PREVOST

WARRANTY BULLETIN

WB15-26B

DATE :	MAY 2015	SECTION :	12 - Brakes
EXPIRATION:	MAY 2017		
SUBJECT :	BRAKE HOSE INSPECTION

Figure 1

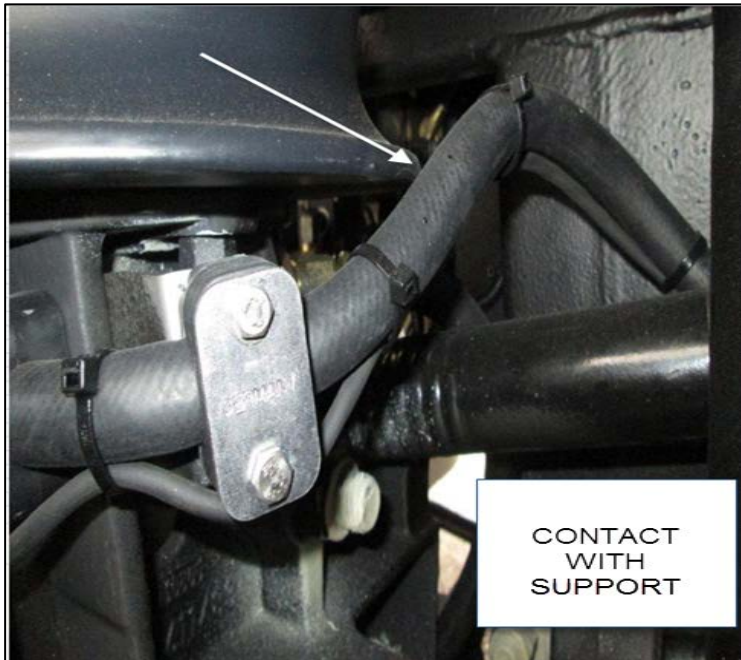
1. On each side of the vehicle, make sure that the brake hose to the brake booster does not come into contact when suspension is in low or high buoy.
2. If no contact is found, end the bulletin here.

Figure 2

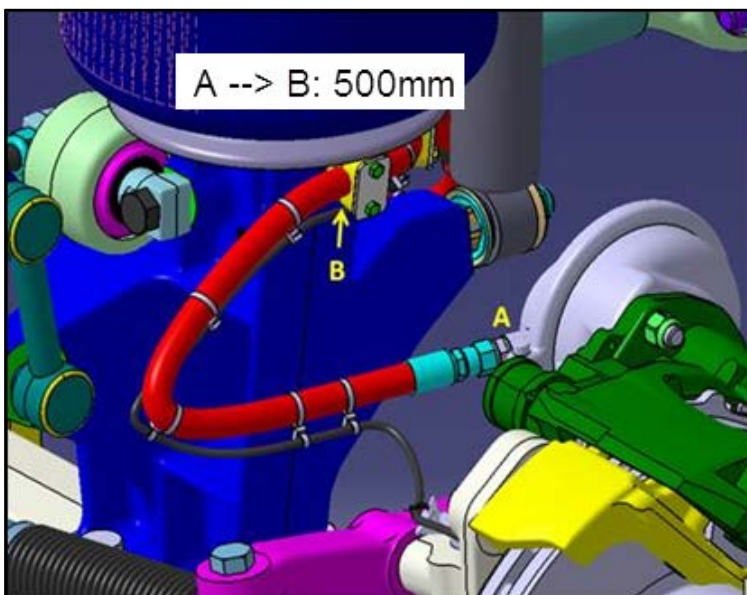
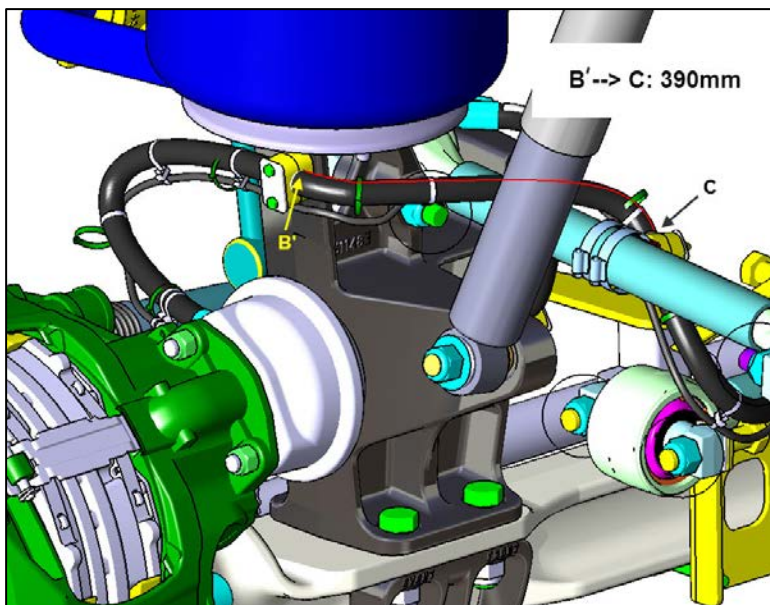
3. If there is interference, reposition the hose on each side of the vehicle as shown in fig. 2 and 3.

4. Measure and mark distances below on hose and adjust hoses as required to avoid interference.
 - From A to B: 500mm (19 5/8")
 - From B' to C: 390mm (15 3/8")
